14-AMRP-0286

COMPLETION OF HANFORD FEDERAL FACILITY AGREEMENT AND CONSENT
ORDER (TRI-PARTY AGREEMENT) MILESTONE M-089-06-T01

Tri-Party Agreement Milestone M-089-06-T01, "Submit the 30% design of the closure of mixed waste units in the 324 building REC B cell, REC D-cell, and high level vault and low level vault that includes a schedule to complete the design," due September 30, 2014, is complete. This milestone consists of the 30 percent design for remediation of the high radiation dose portion of waste site 300-296 (contamination under 324 B-cell) and the 30 percent design for removal of hot cells and vaults. The 30 percent design for 300-296 remediation was prepared for Washington Closure Hanford LLC (WCH) by AREVA Federal Services as part of the current ongoing design effort. The 30 percent design for hot cell removal was prepared for WCH by Northwest Demolition and Environmental in 2010.

DWG NO: KUR-1782F-DWG-C003
 SHEET 01

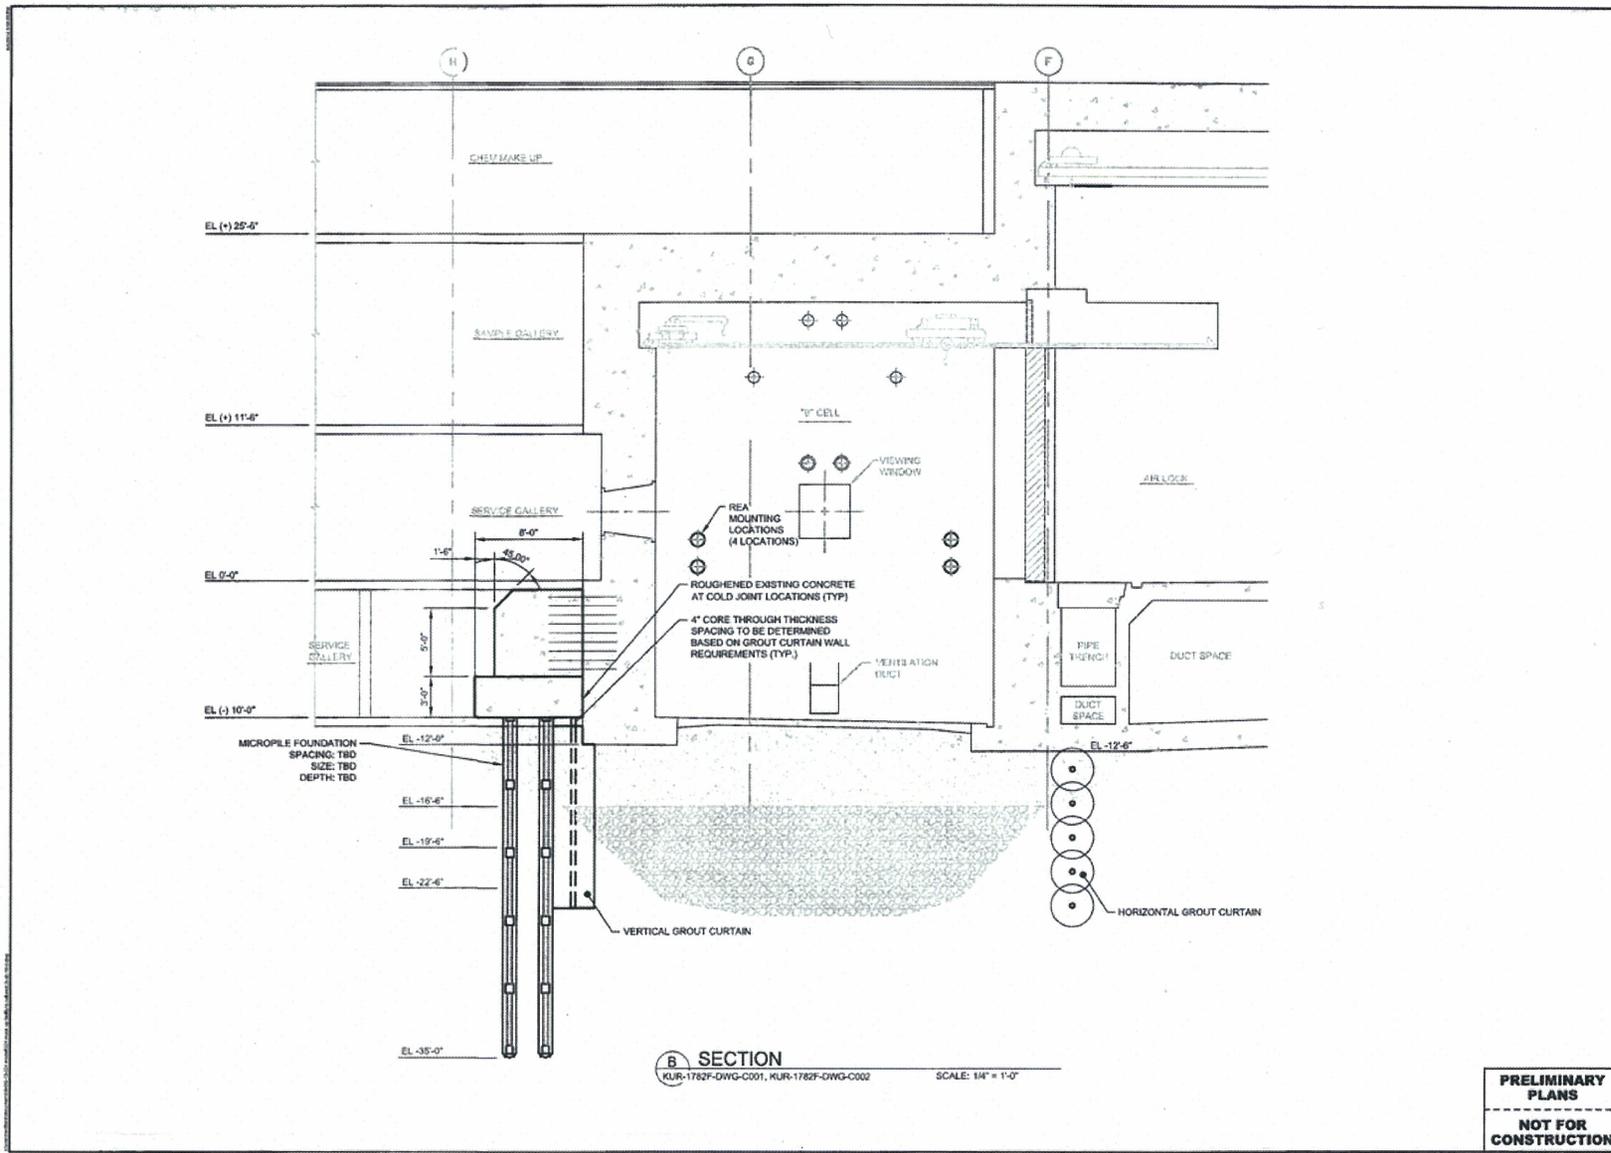
57	Drawings General	Are the drawings to scale, if so what is the scale. Add the scale to the drawings. (TK)	X		ACCEPTED <i>As the design progresses to 60% drawing scale will be added to the drawings. (WS)</i>
58	Drawing KUR-1872F-DWG-C003	The horizontal grout curtain location (shown in Section B on KUR-1782F-DWG-C004) is not shown on the drawing. A drawing showing the excavation required to install the horizontal grout curtain will be required. (TK)	X		PARTIALLY ACCEPT <i>As of the 30% design, the horizontal curtain wall installation is to be performed by directional drilling. As the design evolves, or when the actual location of drilling is identified, it will be shown on the drawings. This will be addressed further in the 60% design phase. (RR)</i>
